SS "CACIQUE".

With reference to your letter of 17th October, 1910, which perhaps you may recall, and which gave me the result of calculations made by your Office regarding the damage which the above vessel sustained during her first voyage to the girders under the maindecks in #3 hatchway and the deck itself.

Rough sketch of Girder under decks

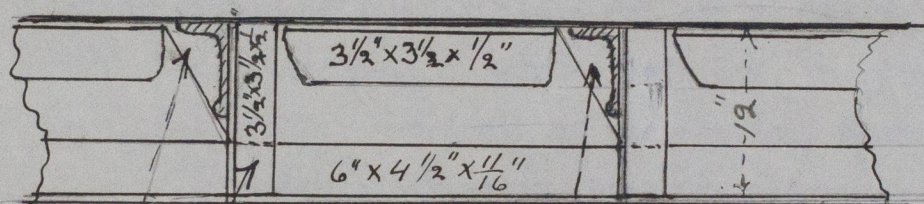
My own opinion is that it is more the fault of construction than of design, and I enclose you a rough sketch illustrating this view. On the sketch you will note that the vertical plate forming the backbone of the girder is cut away to allow the bulb beams to pass through and that

compensating strength by means of an angle lug has only been given to the vertical plate on the flat side of the bulb beam.

I think that you will agree with me that the only strength left in the girder is the depth of the bottom angles, viz: 4 inches. To put it in a more concrete form, if you were to take a saw and cut from the bottom of the triangular piece cut out to the bottom of the girder, you would have absolutely no girder left and, therefore, you have two-thirds practically of the strength of the vertical member of your girder cut away.

Vertical plate cut away to allow
bulk beams to pass through.

Compensating angle lug on one side of beam.
